FILE NH-006-2(55), Dougherty County
SR 3/ Liberty Expressway @ North Jefferson St.
P.I. No. 422550

SUBJECT **Value Engineering Implementation Reversal / Revision Request**

SUBJECT Value Engineering Implementation Reversal/Revision Request

PROJECT: SR 133/N. JEFFERSON ST. FROM SR 520/US 82 LIBERTY EXPRESSWAY TO SR 91/PHILEMA RD. INTERCHANGE RECONSTRUCTION NH000-0006-25(055); PI No. 422550 Dougherty County, Georgia	ALTERNATIVE NO.: S-1
DESCRIPTION: REDUCE THE RAMP A BRIDGE WIDTH FROM 34 FT. TO 30 FT.	SHEET NO.: 1 of 3

TYPICAL SECTION NO. 3

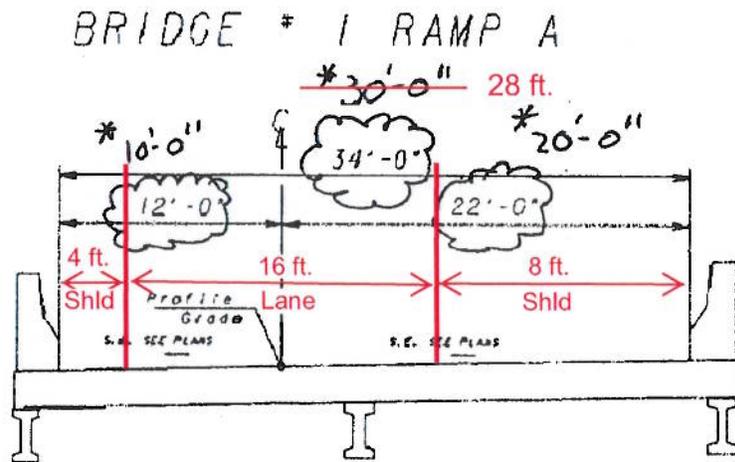
Alternatives S-1 and S-2 recommend reducing the bridge widths on Ramp A (from 34-ft to 30-ft) and Ramp B (from 42-ft to 38-ft) by narrowing the shoulders 2-ft on each side. The VE implementation letter states that these alternatives will be implemented; this office requests to revise the implementation of these alternatives. Recent discussions between Roadway Design and Bridge Design have led to a decision that the bridges should carry the full width of the ramp lane plus the width of the paved shoulders (guidance in AASHTO 2004 Green Book, pg. 506). Applying this guidance results in bridge widths of 28-ft and 40-ft for Ramps A and B respectively.

The bridge on Ramp A will carry a 16-ft travel lane, 4-ft paved inside shoulder, and 8-ft paved outside shoulder, for a total "gutter to gutter" bridge width of 28-ft. This width is 2-ft less than the VE study recommended. Based on the VE study calculations, a bridge width of 28-ft would result in a cost savings of approximately \$116,000 compared to the VE recommendation of 30-ft which showed a cost savings of approximately \$71,000.

Reduce the bridge width to ~~30 ft.~~ ^{28 ft.} from gutter to gutter including a 16 ft. travel lane, ~~10 ft.~~ ^{8 ft.} outside shoulder, and 4 ft. inside shoulder

* Reduced shoulder width by 2'-0" on each side.

TYPICAL SECTION NO. 4

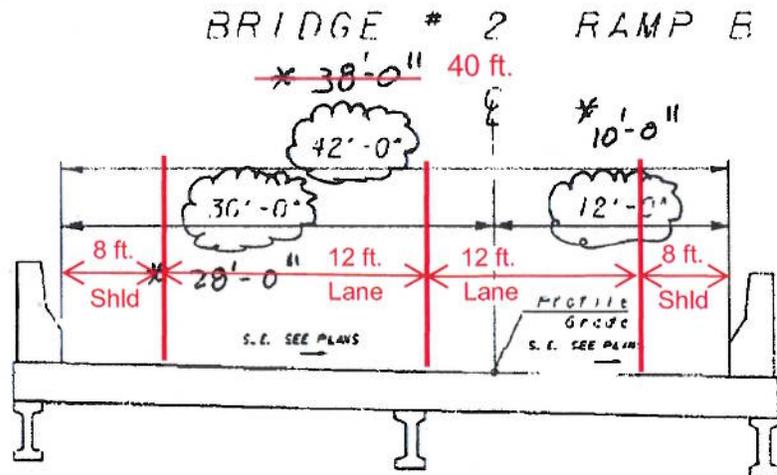
The bridge on Ramp B will carry two 12-ft travel lanes, an 8-ft paved inside shoulder, and an 8-ft paved outside shoulder, for a total "gutter to gutter" bridge width of 40-ft. The resulting width is two feet greater than the VE study recommendation. The inside paved shoulder near Ramp B is 8-ft wide to accommodate a concrete barrier on top of a fill wall that will tie to the bridge barrier. The inside shoulder on the ramp bridge is 8-ft wide so the bridge barrier will align with concrete barrier on top of the wall without having to taper as it approaches the bridge. Based on the VE study calculations, a bridge width of 40-ft would result in a cost savings of approximately \$65,000, compared to the VE recommendation of 38-ft, which showed a cost savings of approximately \$130,000. The result of revising the implementation of Alternatives S-1 and S-2 is a total cost savings of \$181,000, compared to the VE cost savings of \$201,000.

Reduce the bridge width to ~~38 ft.~~ **40 ft.** from gutter to gutter including two 12 ft. through lanes, a ~~10 ft.~~ **8 ft.** outside shoulder, and a ~~4 ft.~~ **8 ft.** inside shoulder.

* Reduce shoulder width by 2'-0" on each side.
